ITEM FOR ENVIRONMENTAL COMMISSION AGENDA

NAME & NUMBER OF PROJECT: Manor ISD Elementary School #10 (SP-2022-0095CX)

REQUEST: Variance request is as follows:
Request to vary from LDC 25-8-342 to allow fill over 4feet up to 33feet.

Project Name: Manor ISD Elementary School #10
Ordinance Standard: Watershed Protection Ordinance
Variance Request: **To allow for fill exceeding 4 feet up to 33 feet for building construction**

1
C104 2017 Cut and Fill Map
SCALE: 1" = 60'

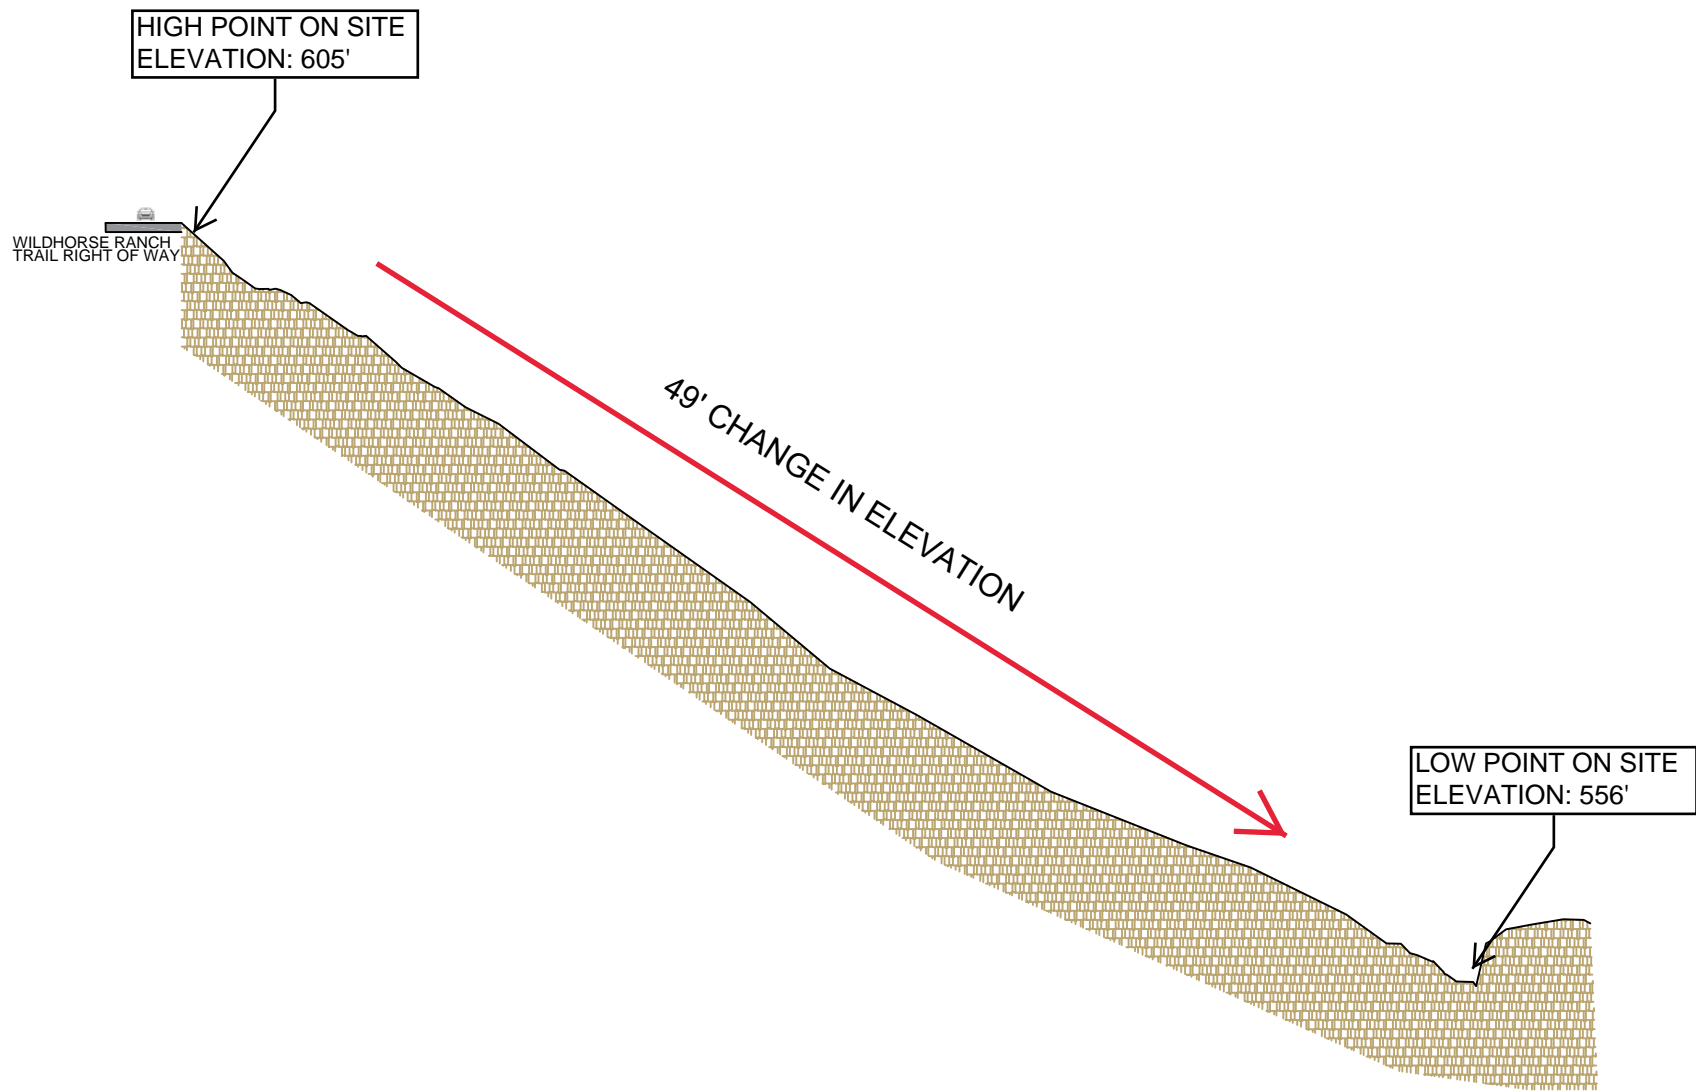
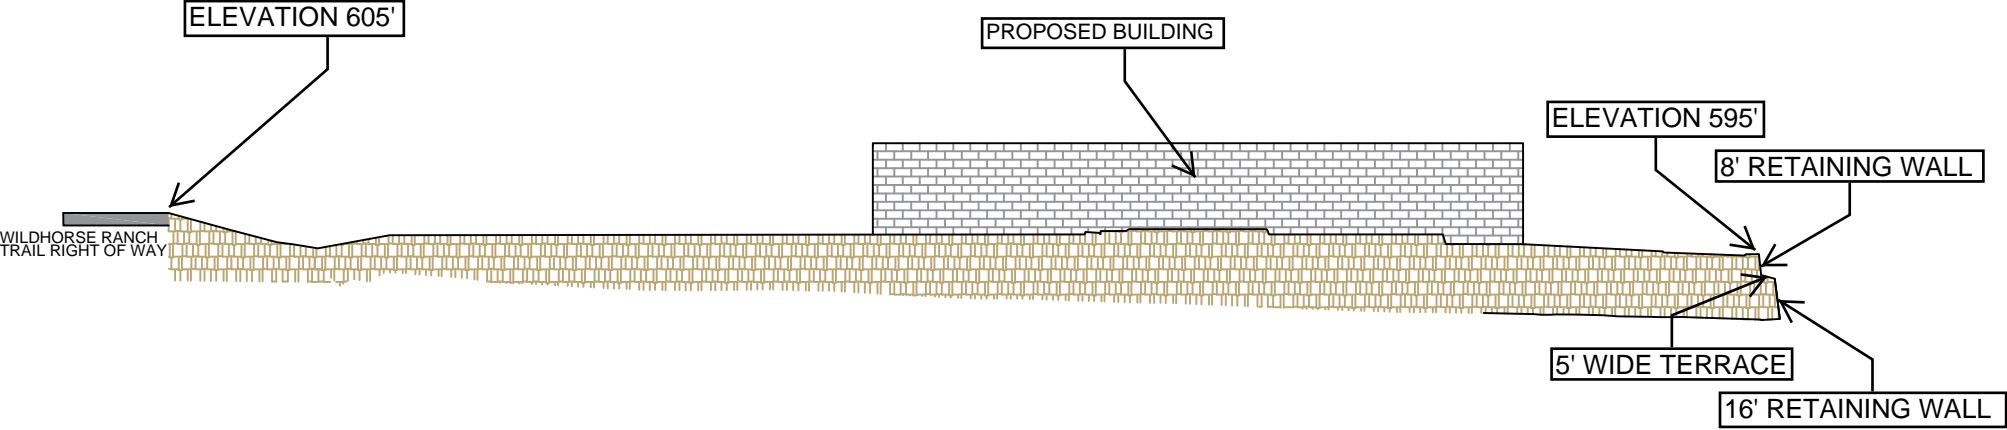
Clearly indicate in what way the proposed project does not comply with current Code (include maps and exhibits)	The proposed project contains fill greater than 4 feet up to 33 feet.
---	---

- Provide structural containment of fill with a terraced retaining wall where applicable.
- Increase tree inches by adding 20 native trees over required number of trees.
- Provide pollinator plants along with educational signage for the children.
- Use rainwater harvesting on site.

- Provide structural containment of fill with a terraced retaining wall where applicable.
- Increase tree inches on site by adding 20 native trees over the required number of trees.

COURTYARD PLAN
SCALE: 1"=10'
CL103

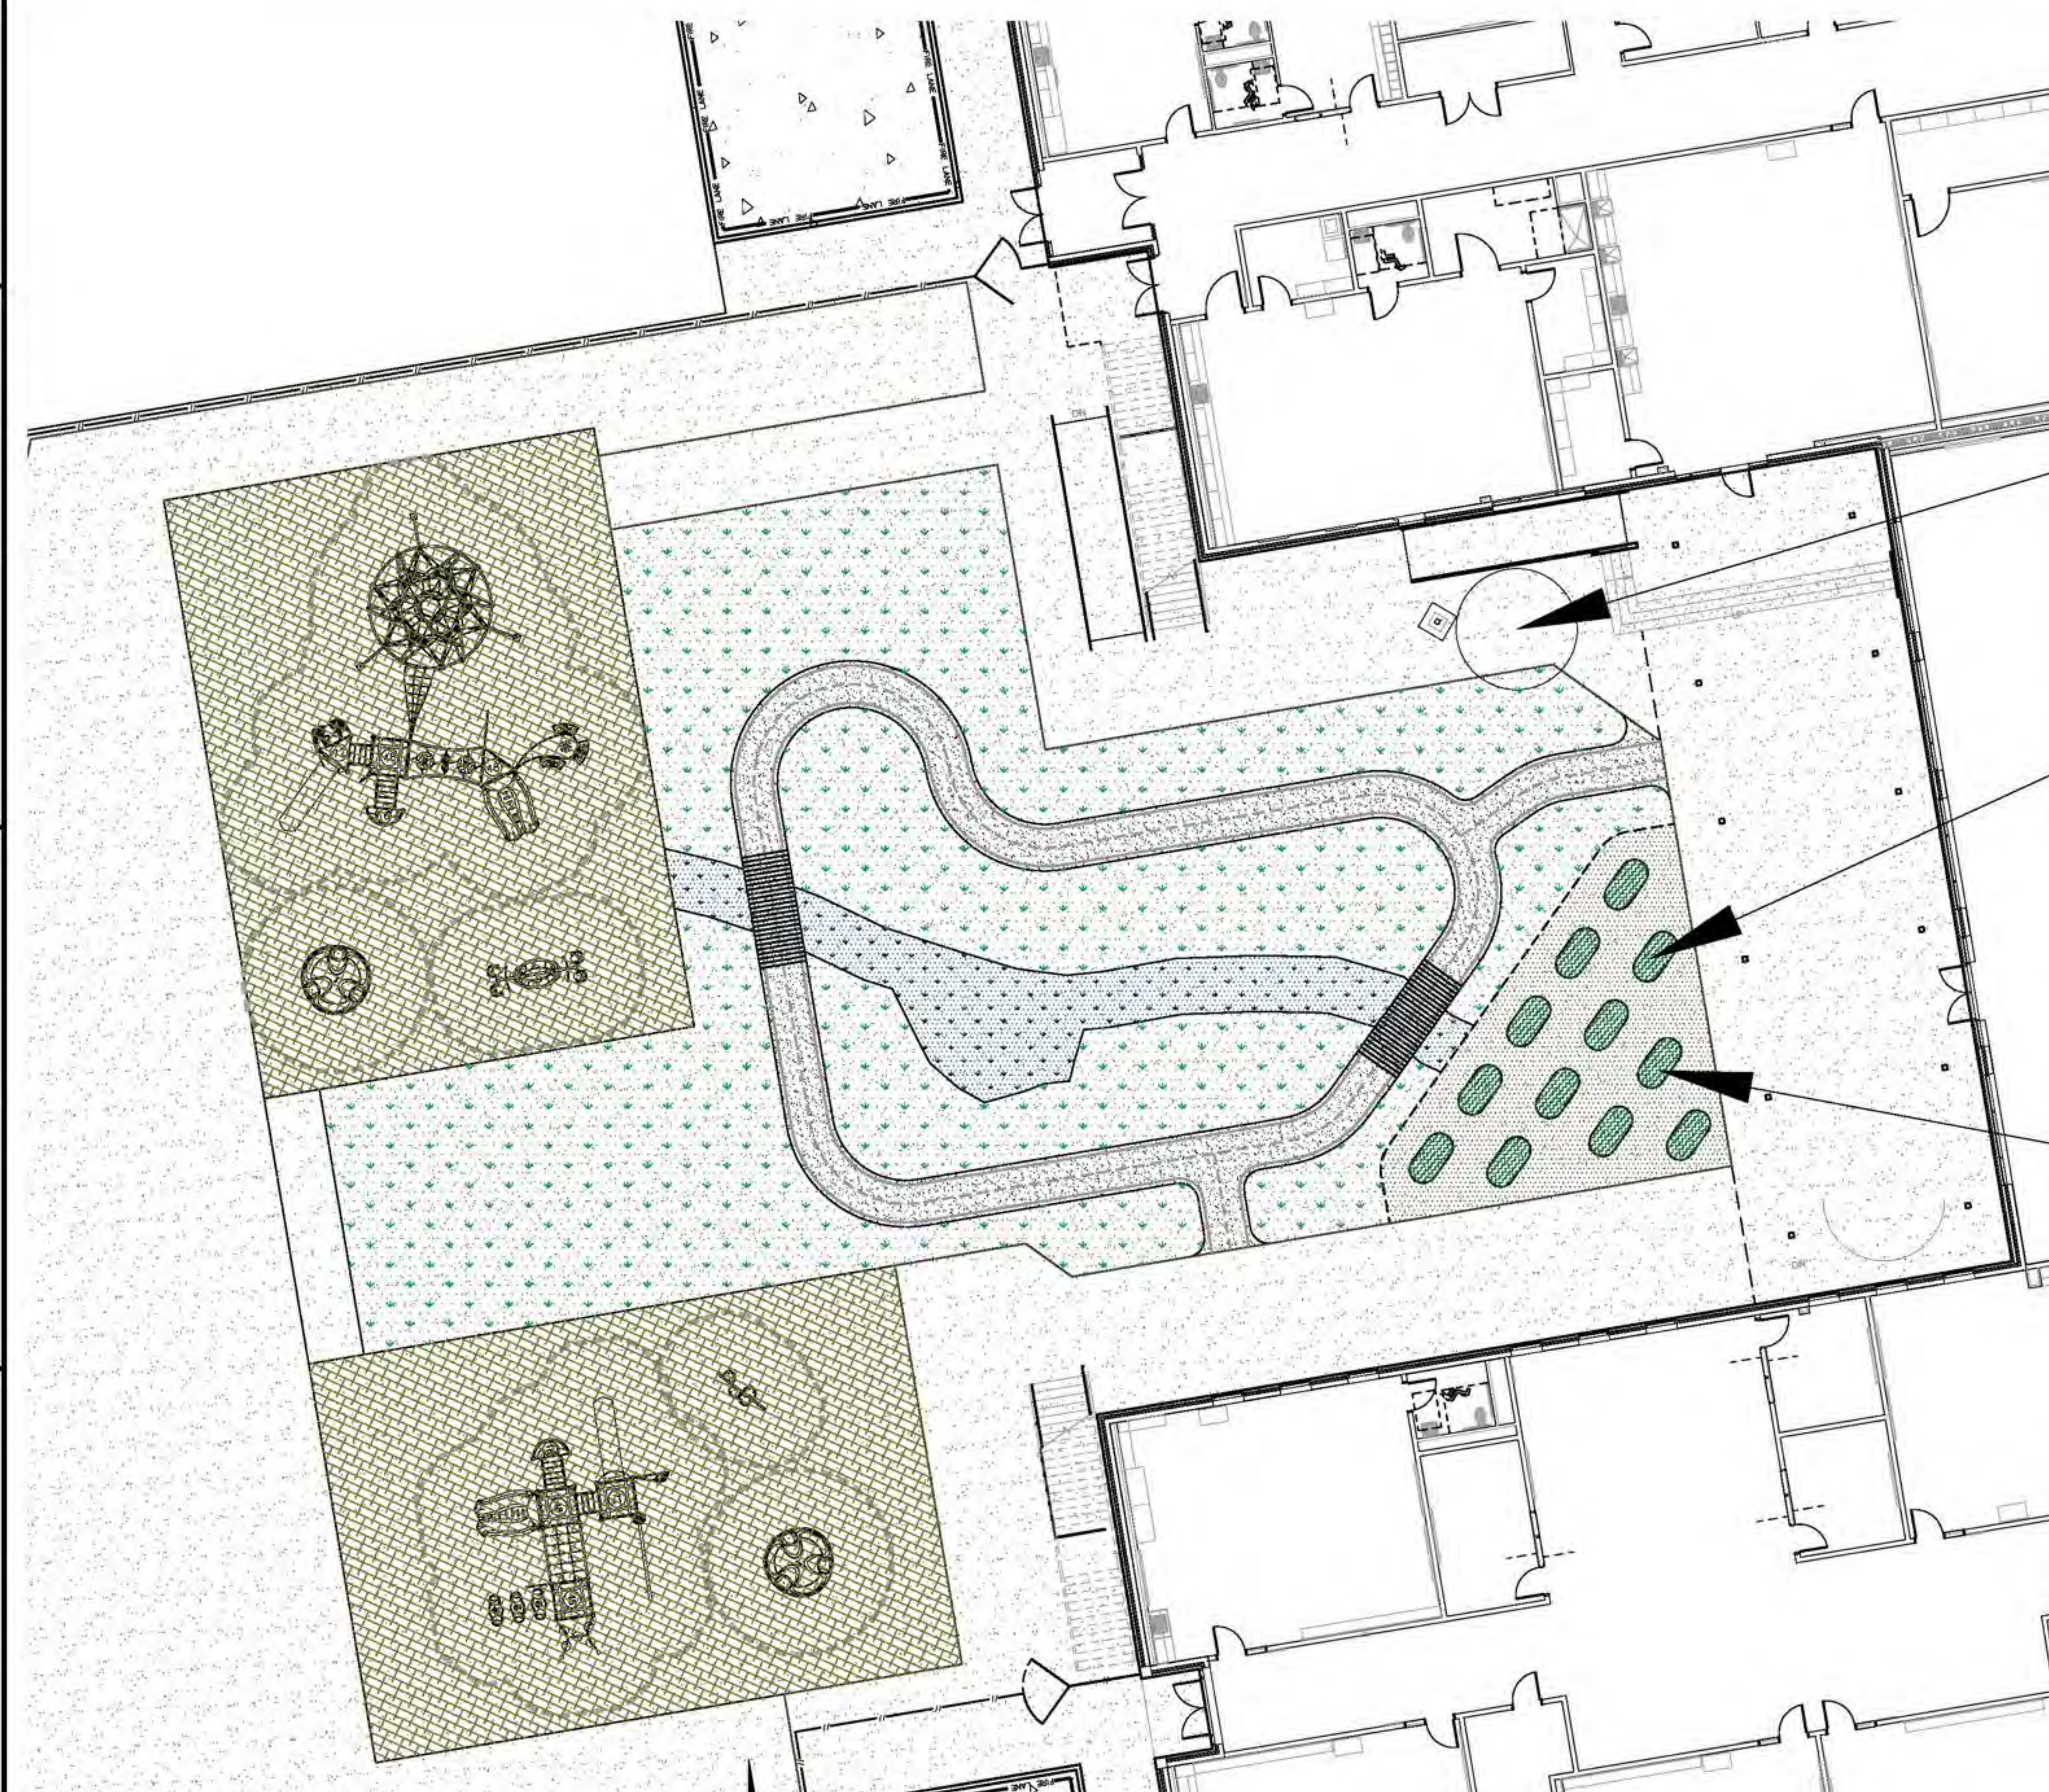
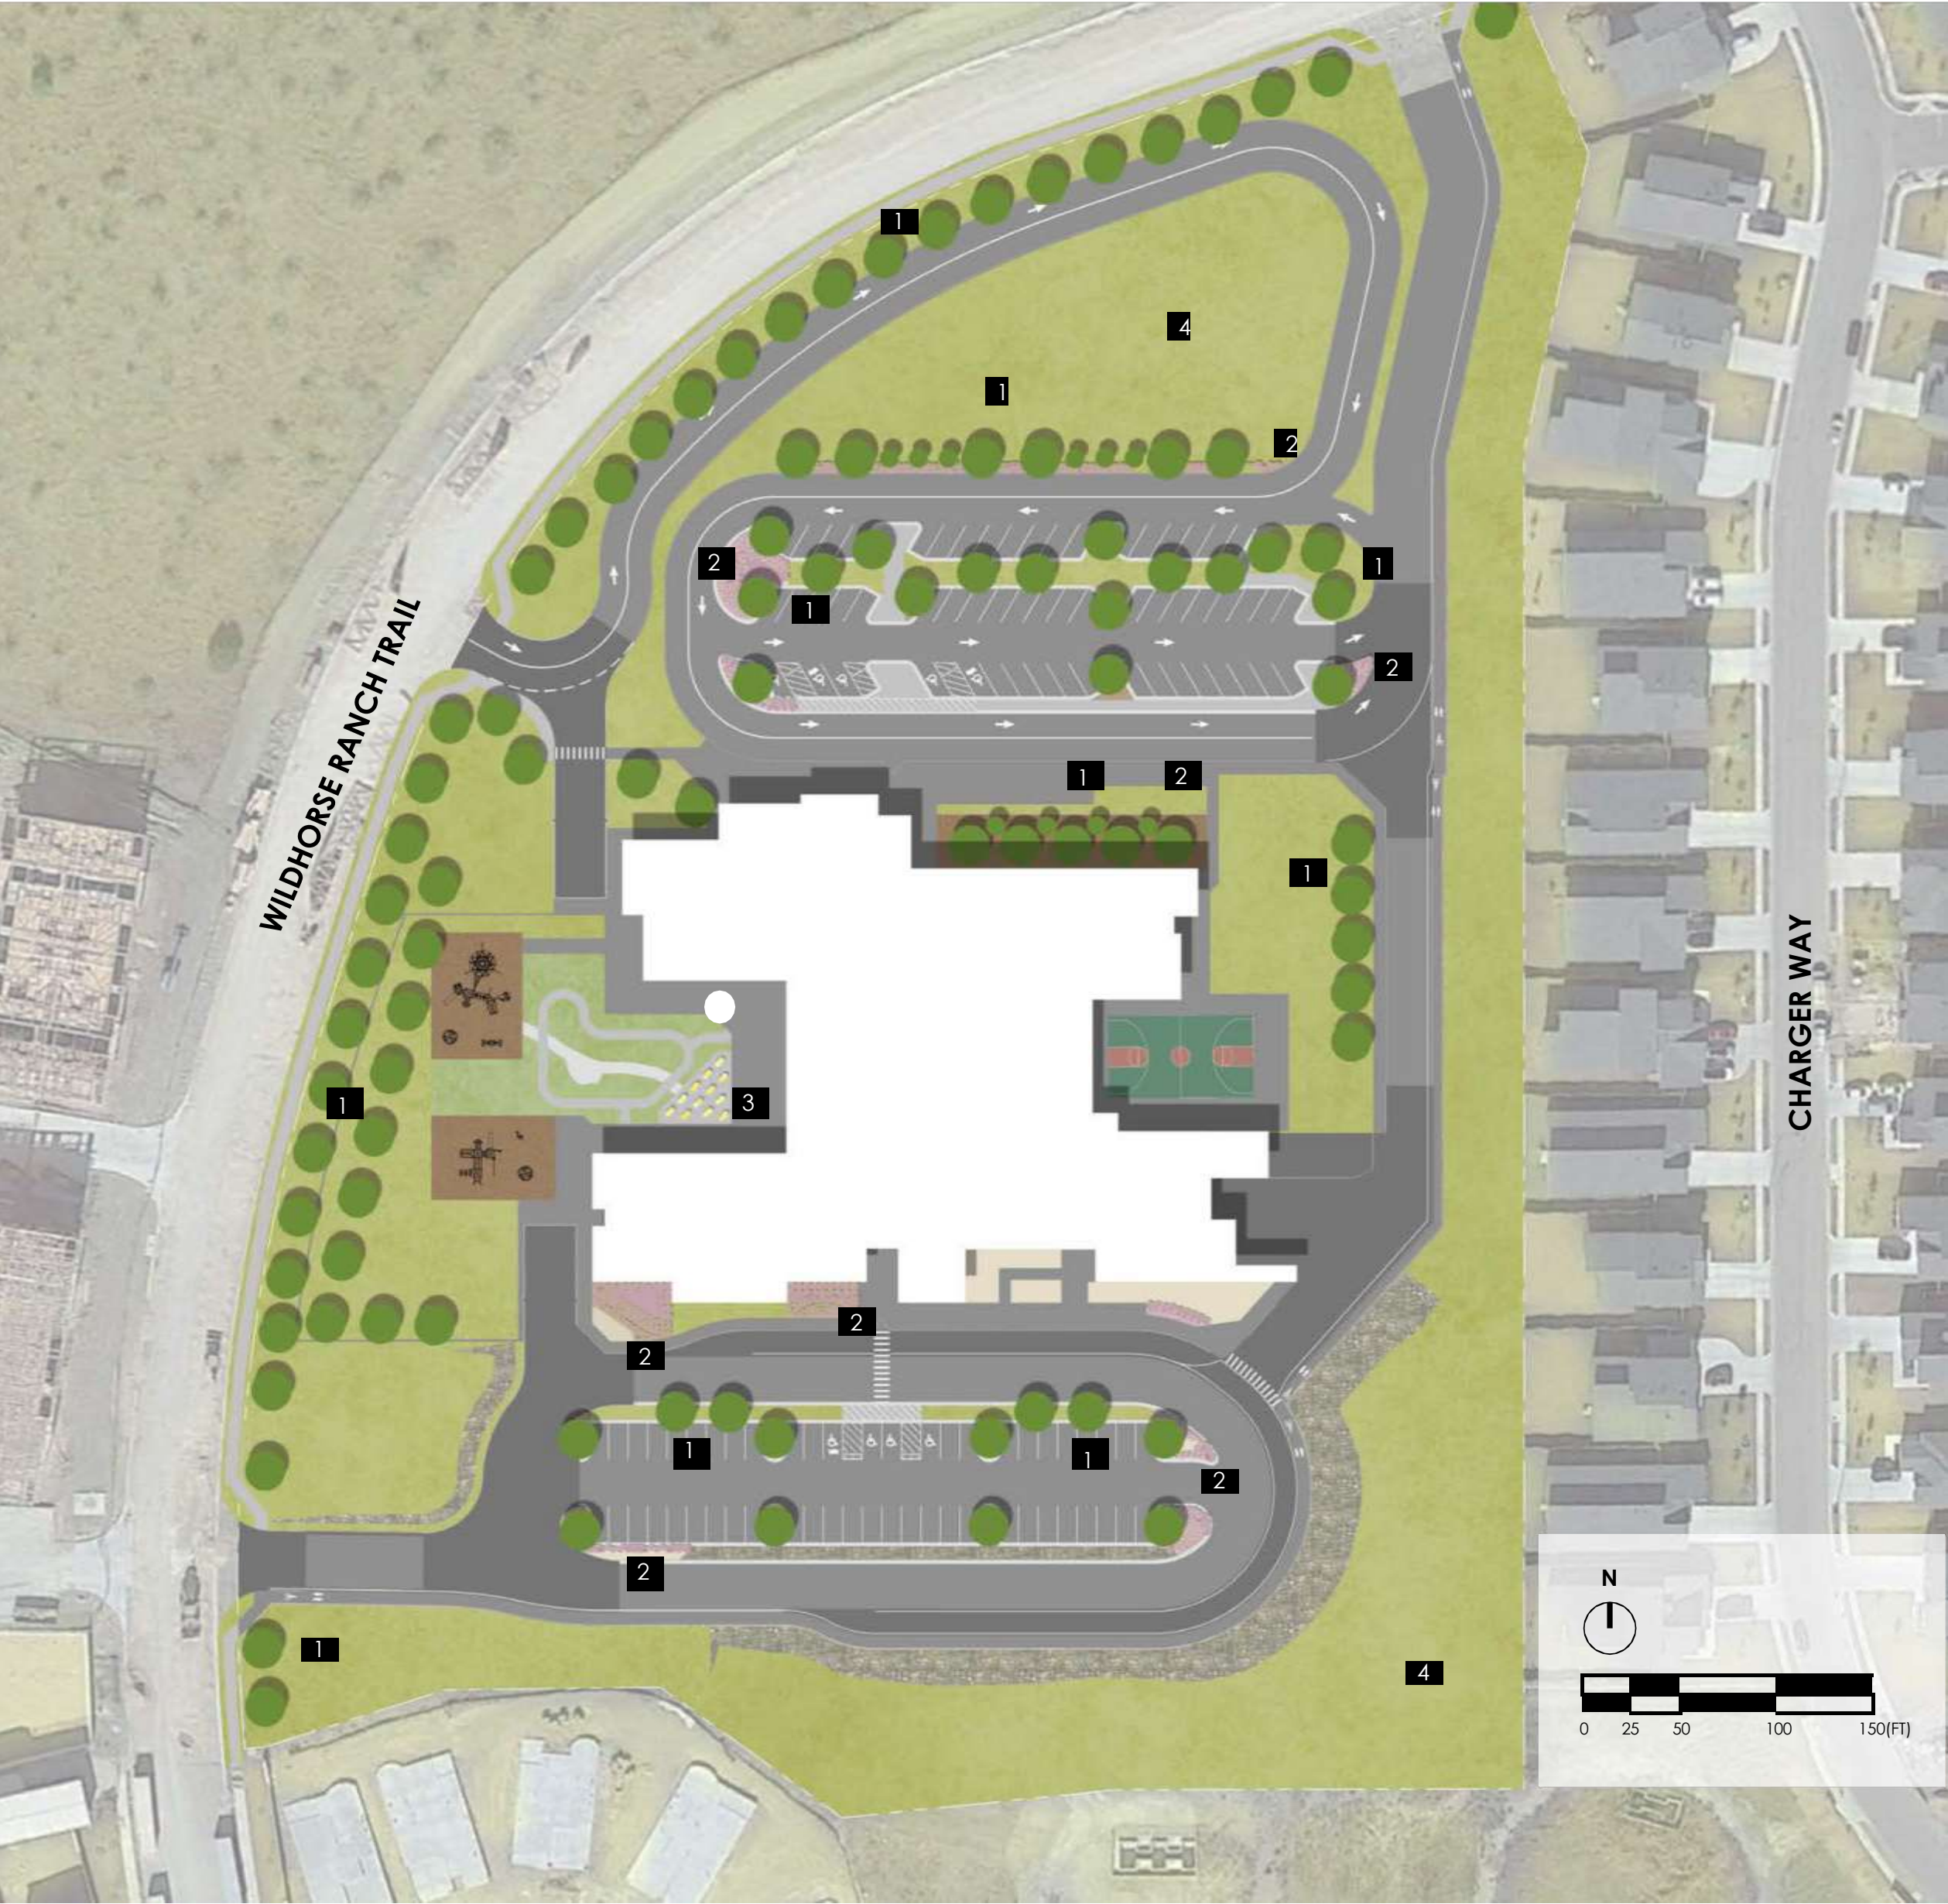
- Provide pollinator plants along with educational signage for the children.
- Use rainwater harvesting on site.

RAIN
COLLECTION
TANK

ABOVE GROUND PLANTERS
TO CONTAIN POLLINATOR
PLANTS AND EDUCATIONAL
SIGNAGE

ABOVE GROUND PLANTERS
WITH WICKING BED
CONNECTED TO RAIN
WATER COLLECTION
